Product / Process Change Notification (PCN)

PCN #: PCN_ConUSB2_20211013
Affected Series: WE-ConUSB2; 629105150921

PCN Date: July 13, 2021
Effective Date: October 13, 2021

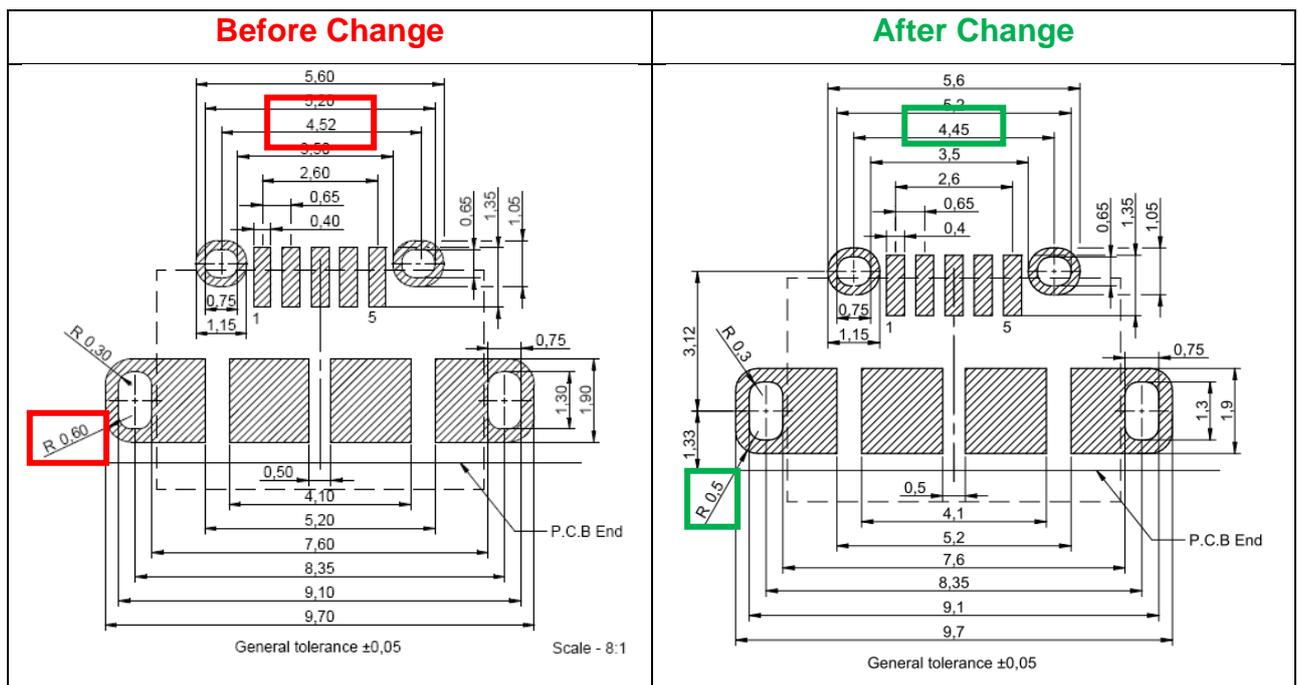
Because of a database mismatch, Würth Elektronik is correcting the datasheet for this product with more accurate references.

This is a datasheet correction only. There will be no change in form, fit, function, quality or reliability of the product.
